Applicant : Miachel A. Robinson
Serial No. : 09/785,051
Filed : February 15, 2001
Page : 11 of 11

Attorney's Docket No.: 10004159-1
Amendment dated February 3, 2004
Reply to Office action dated November 13, 2003

Application No.: 09/785,051
Amdt. Dated: Feb. 3, 2004
Reply to Office Action Dated: Nov. 13, 2004
Annotated Sheet Showing Changes

FIG. 2A

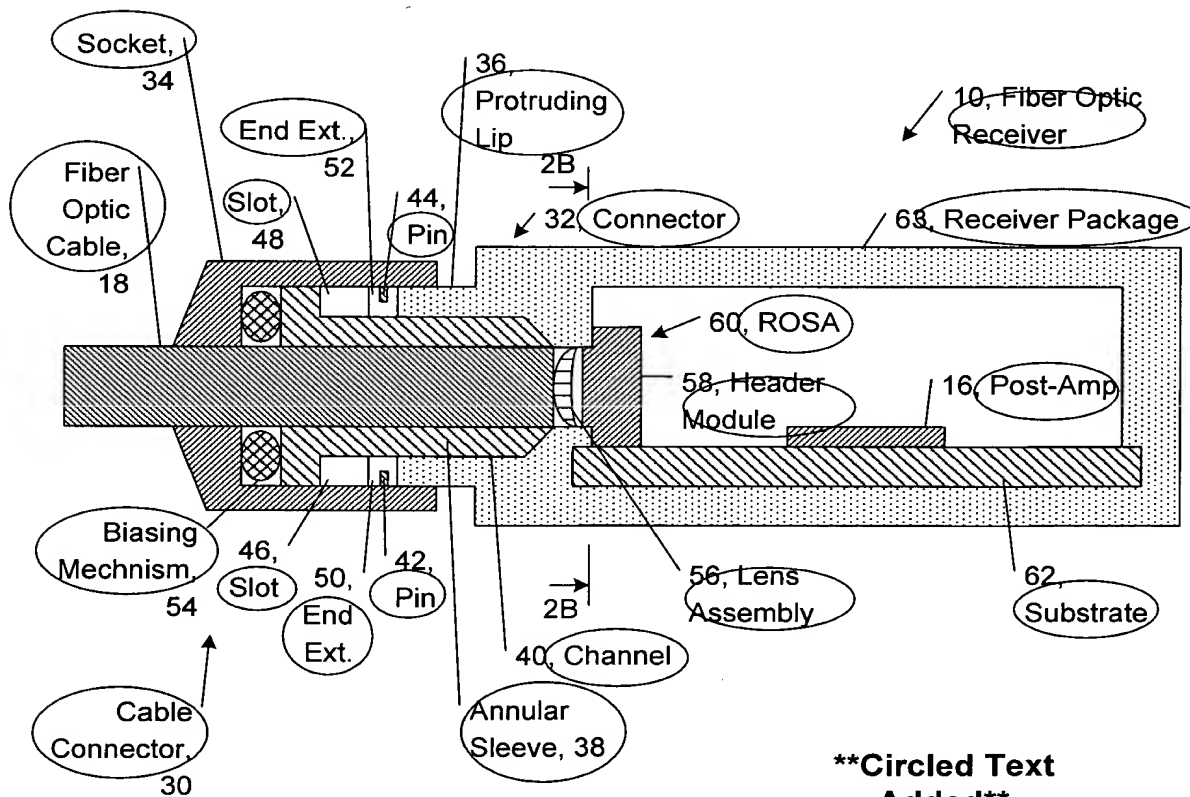
FIG. 2A has been amended as requested by the Examiner. The Examiner's objections to the drawings now should be withdrawn.

****Circled Text
Added****
